INDESIT company

Model type:
BSZ3032V

Commercial code:
F055935

0521123: SEALS FOR DOORS FOAMED AS ONE PIECE

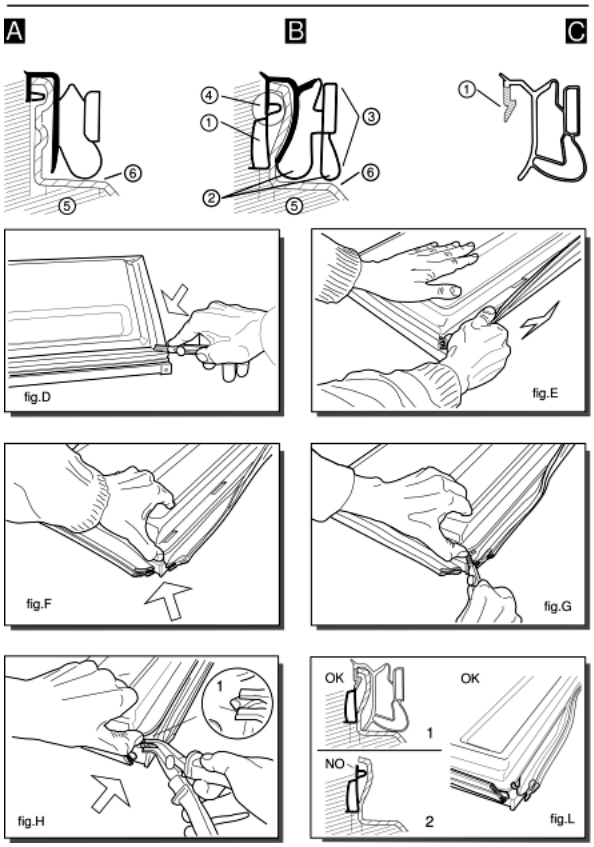
Various types of gaskets with different profile, as shown in figures (A) and (B), are used to fix the door (fig. A-5; B-5) and the inner door (fig. A-6; B-6) on the block foamed doors of combined freezers and refrigerators.
---Ilpea profile 245; 179; 412 (fig.A)
---Ilpea profile 287 (fig.B)
When replacing gaskets with profiles 245; 179; 412 these are fixed with screws (2 per corner) to the door.
Gaskets with profile 287 can not be used as spare parts but are designed to house the Ilpea type 900 gaskets (see figure C).
When replacing the gasket (287), once it is removed you will find a pocket (fig. B-1) between the door and inner door.
The rigid tooth (fig.C-1) of the gasket (900) is inserted inside between the pocket and the inner door, doing away with the need for screws.
Gasket with profile 287 is easy to identify since it has an exterior double edge (fig.B-2) which acts as a cushion when the door is closed.

To replace this gasket, follow these steps:
---Dismount the door and cut the four corners of the gasket along the joint (fig.D);
---lift the gasket and pull it carefully along its full length without tearing it (fig.E).
The purpose here is to detach the inner door slightly from the foam along the exterior edge for a depth equal to that of the gasket (fig.B-3);
---lift the corner of the inner door slightly, prising it up with your thumb (fig.F). Do not use a tool which might break the inner door;
---continue cutting the gasket inside the inner door for about 6 mm (fig.G);
---push in the tip of the pliers (type USAG N131) and pull outwards until you see the top edge of the pocket (fig. B-4) which is empty (fig.H-1);
---if you carry out this operation correctly (fig.L) you will be able to pull off the top edge of the pocket for the full length of the door.
If the gasket tears before the top edge (fig. L-2) you should repeat this operation from the other corner of the door.

---once the gasket (287), has been removed the space above the pocket (fig. L-1) can house the rigid tooth (fig. C-1) of the gasket 900.
When you fit this gasket ensure that it lies flush against the edge for the full length of the door.
If the rigid tooth is difficult to fit, eliminate any residues of foam between the door and the inner door in the gasket area.
fig.5131549A

n3010j01: Colour Change of Internal Accessories

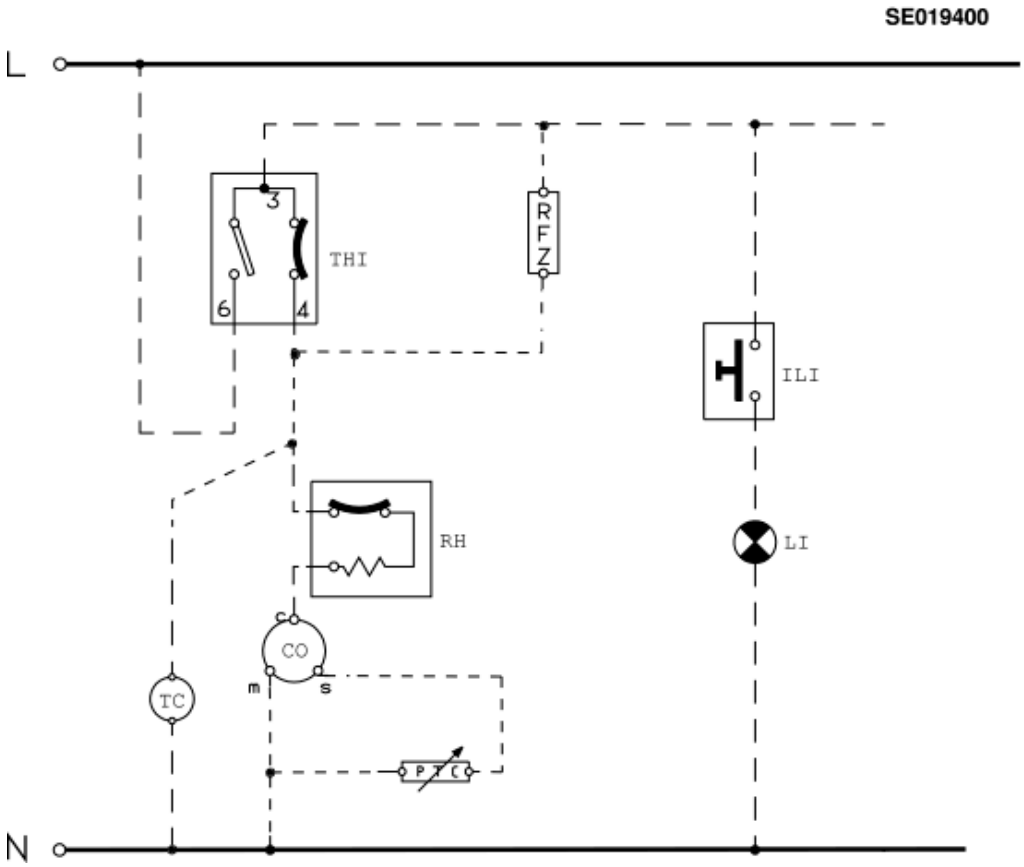
The colour of some of the internal shelves and accessories have changed to transparent. This affects models produced in Carinaro-Manisa. Modification is functionally interchangeable therefore once the colour versions of the parts have depleted they will automatically substitute to its corresponding transparent parts. Some parts will have been made obsolete with no substitution.

Some parts have changed from Satin Finish to Shiny (Crystal) Finish. These parts include;
-Door Shelves
-Crisper Front Panels
-Freezer Drawer Front Panels
All pre-modification components will be managed till the end of stock and after they will be substituted with new version.
